## River Deel (Crossmolina) Drainage Scheme

NIS Addendum

<b>Client</b>	<b>Office of Public Works</b>
<b>Project Title</b>	<b>River Deel (Crossmolina) Flood Relief Scheme – Environmental Services</b>
<b>Report Title</b>	<b>NIS Addendum</b>

TITLE  
**LAYOUT PLAN  
(Sheet 1 of 4)**

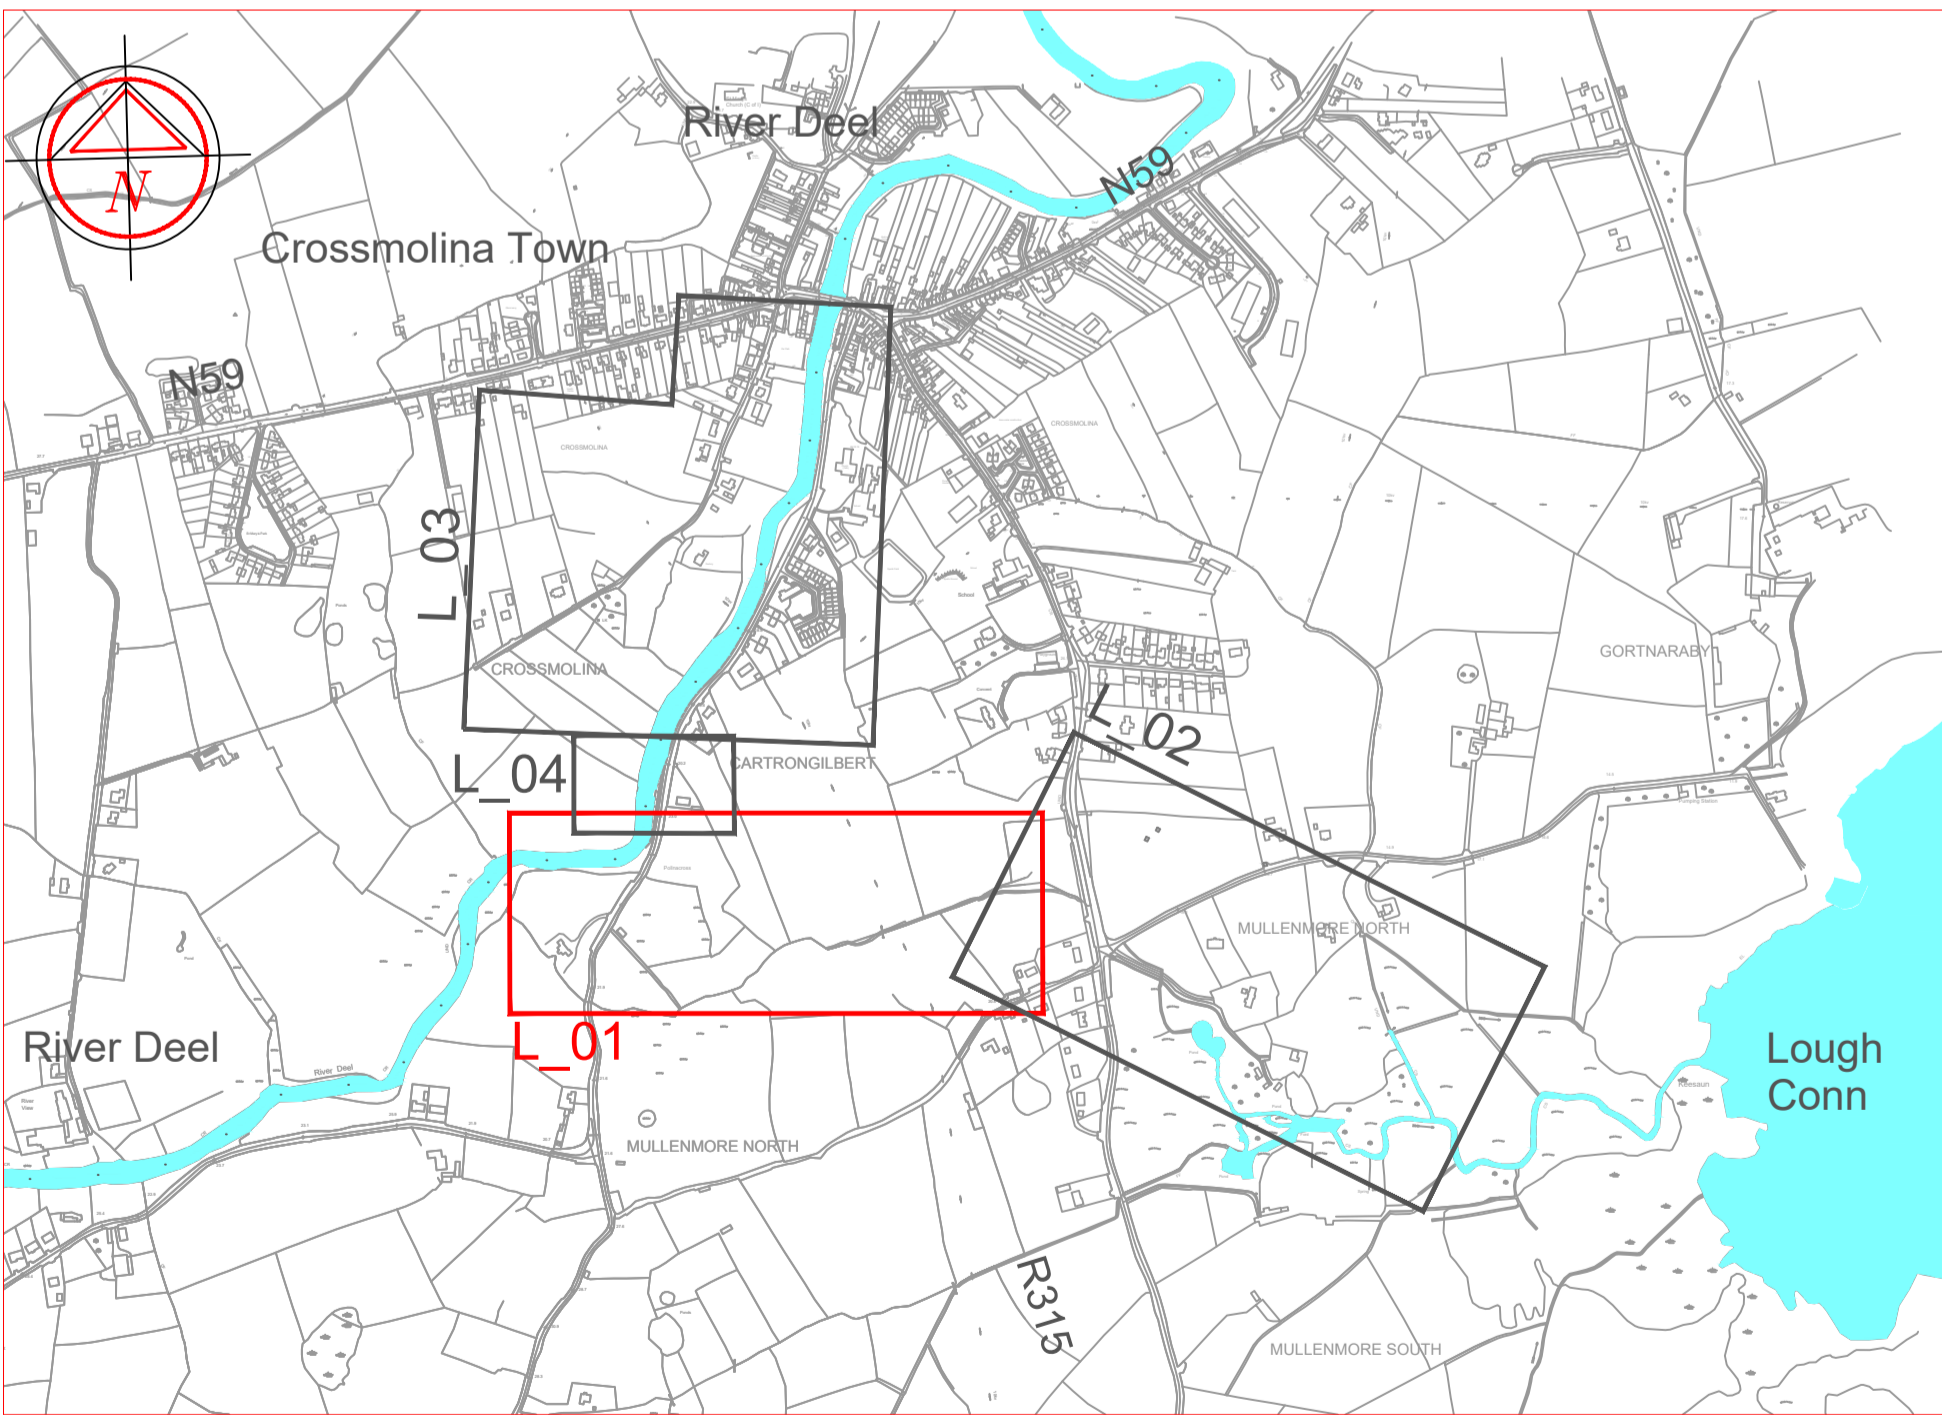
- Rock armour/ stone gabions will be placed in order to provide scour protection to the river banks upstream and downstream of the intake location as detailed in Appendix II (Drawings L\_01 and S\_01) and (Drawing SP\_01). This bank protection extends 90m upstream of the proposed intake structure and 80m downstream of the structure and will be undertaken by excavating on the bank and replacing the excavated material with rock armour or stone gabions.

C02_C02	N/A	Chainage 900m.	Proposed reinforcement of channel bed and banks to provide scour protection. Proposal to incorporate gravel rip-rap, extending circa. 80m downstream from intake spillway.	C02_R03	N/A	Chainage: 925m.	Raise and regrade road (L1105) to tie in with bridge.
C02_C03	N/A	Chainage 1000m	Proposed reinforcement on spillway banks to provide scour protection. Proposal to incorporate gravel rip-rap.	C02_R04	N/A	Chainage 925m.	Proposed new 4m wide access driveway. Driveway to be sufficient distance from bridge to allow for road safety barriers at the bridge.
C02_G01	N/A	Chainage 925m.	67m proposed permanent parapet/ fencing and 4m gate. Proposed hedgerow with native species to be used.	C02_R05	N/A	Chainage 264m to 909m.	Proposed entrance carpark and 664m long 4m wide access track and 2 No. access ramps approx. 15m long to allow vehicular access to the channel for inspection and maintenance. Track minimum of 5m from edge of channel.
